Project	IEEE 802.16 Broadband Wireless Access Working Group < http://ieee802.org/16 >	
Title	A Generic Packet Convergence Sublayer (GPCS) for Supporting Multiple Protocols over 802.16 Air Interface	
Date Submitted	2005-11-17	
Source(s)	Lei Wang, Brian Petry, Yair Bourlas, Kenneth Stanwood, Cygnus Communications Inc. Phillip Barber, Huawei GuoQiang Wang, Mo-Han Fong, Nortel Networks Mary Chion, ZTE San Diego	Voice: 760-448-4168 Fax: 760-448-1989 lwang@cygnuscom.com bpetry@cygnuscom.com ybourlas@cygnuscom.com kstanwood@cygnuscom.com pbarber@broadbandmobiletech.com guoqiang@nortel.com mhfong@nortelnetworks.com marychion@ztesandiego.com
Re:	This is a follow-up contribution on the proposal of a generic packet convergence sublayer.	
Abstract	<p>As requested by 802.16g during the comments resolution discussions in session #39, we are submitting a follow-up contribution on our Generic Packet Convergence Sublayer proposal i.e., C802.16g-05/25, by presenting additional supporting materials and integrating suggestions and comments received from other members.</p> <p>We are concerned that the 802.16 protocol cannot easily be extendable to transport new protocols over the 802.16 air interface.

Figure 17c: GPCS Layering Model

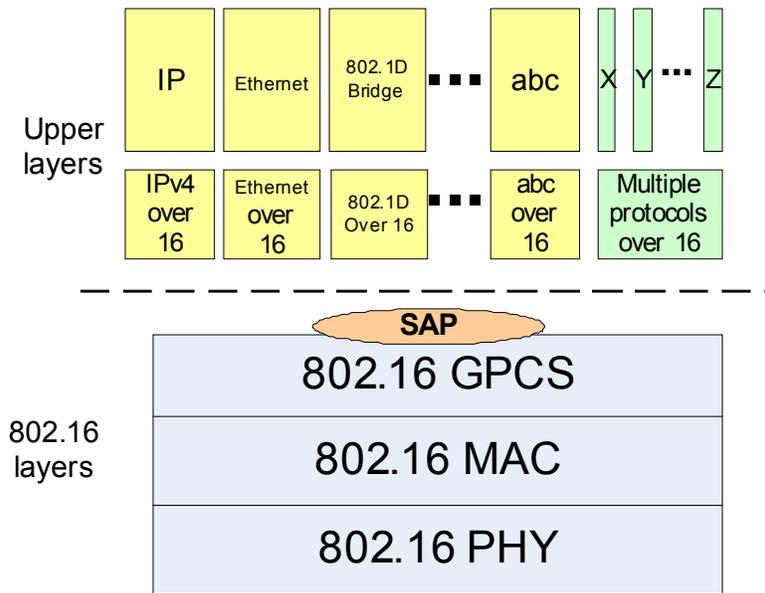
[insert new subclause 5.2.8 and subsequent text below]

5.2.8 Generic Packet Convergence Sublayer (GPCS)

The Generic Packet CS (GPCS) is a upper layer protocol-independent packet convergence sublayer that supports multiple protocols over 802.16 air interface. It is defined as follows:

Figure 17d: GPCS SAP Parameters Model

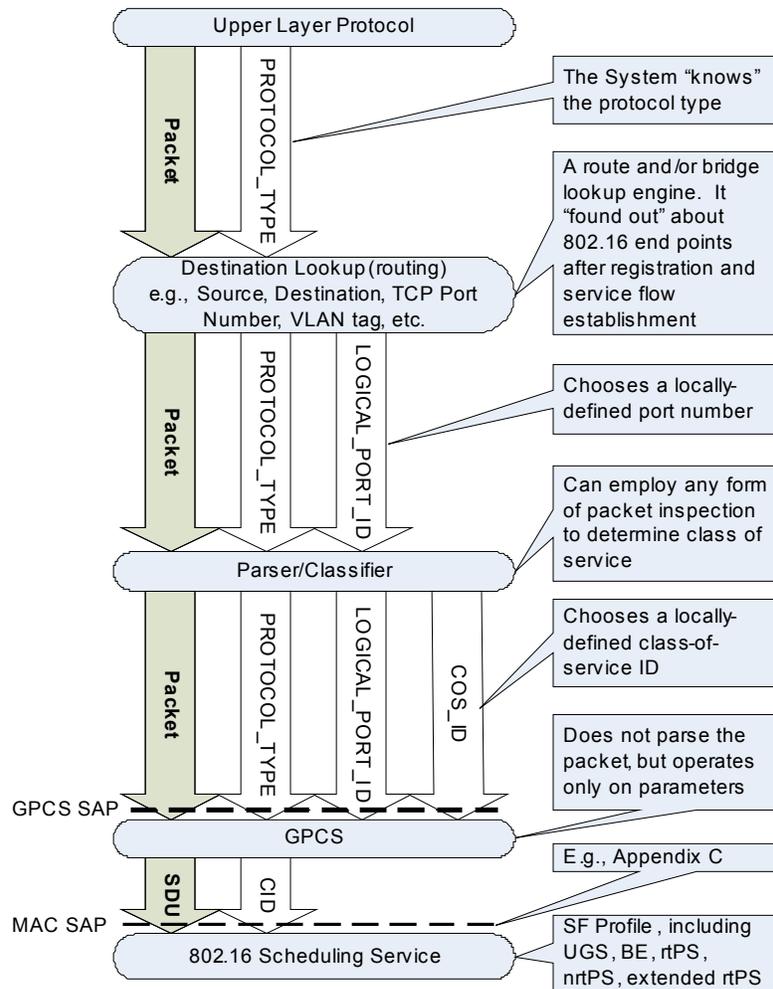
The GPCS SAP parameters enable the upper layer protocols to generically pass information to the GPCS so that the GPCS does not need to interpret upper layer protocol headers in order to mapping the upper layer data packets into proper 802.16 MAC connections. Since the SAP parameters are explicit, the parsing portion of the classification process is the responsibility of the upper layer. The parameters are relevant for SAP data path primitives, GPCS_DATA.request and GPCS_DATA.indication as described in sections 5.2.8.1.2 and 5.2.8.1.3, respectively. ~~{Note to editor: copy specification method from Annex C to this section to describe GPCS_DATA primitives and SAP parameters.}~~

~~There are four GPCS SAP parameters: LOGICAL_PORT_ID, COS_ID, PROTOCOL_TYPE, and MULTI_PROTOCOL_ENABLE. Figure 17d depicts the GPCS SAP parameters model. It shows how the first three GPCS parameters, LOGICAL_PORT_ID, COS_ID, and PROTOCOL_TYPE, can be chosen in a system. The parameter, MULTI_PROTOCOL_ENABLE, is required for signaling whether or not the multiple protocol packets are transmitted on the same CID.~~

Figure 9: PROTOCOL_TYPE Usage by a Receiver

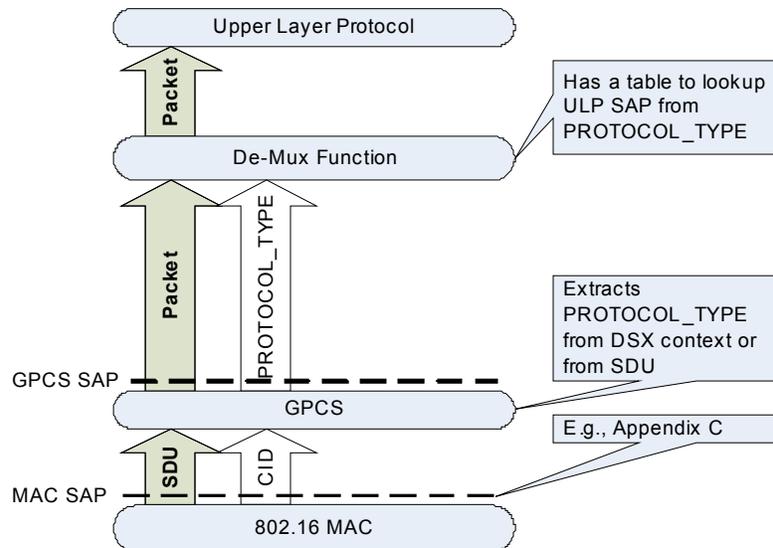
PROTOCOL_TYPE. The protocol type field identifies the upper layer protocol that is immediately above the 802.16 protocols. The PROTOCOL TYPE is included in GPCS DATA.request and GPCS DATA.indication as defined in sections 5.2.8.1.2 and 5.2.8.1.3 respectively. If

MULTI_PROTOCOL_ENABLE is activated, the PROTOCOL_TYPE shall be also carried over-the-air in every SDU, so the 802.16 receiver can demultiplex an SDU and invoke the appropriate upper layer protocol. If MULTIPROTOCOL_ENABLE is not activated, an 802.16 ~~CID-connection~~ can carry only one protocol type, and the PROTOCOL_TYPE field shall be included in ASF.indication primitive and DSx messages during connection establishment. ~~is only communicated during connection establishment through DSx messages. It is thus analogous to the "ethertype" field in an Ethernet packet or the 16-bit PPP data link (DL) layer protocol field in PPP packets. The PROTOCOL_TYPE values are the same as the value of the GPCS PROTOCOL_TYPE encoding as defined in section 11.13.19.3.4.3. The GPCS can either uses the IANA to assign 2-byte 802.16 PROTOCOL_TYPE numbers, or maybe just borrow the number space from PPP. Note that GPCS with MULTIPROTOCOL_ENABLE is just about like Ethernet Packet CS except no Ethernet addresses are transported, and so they don't need to be header-compressed.~~
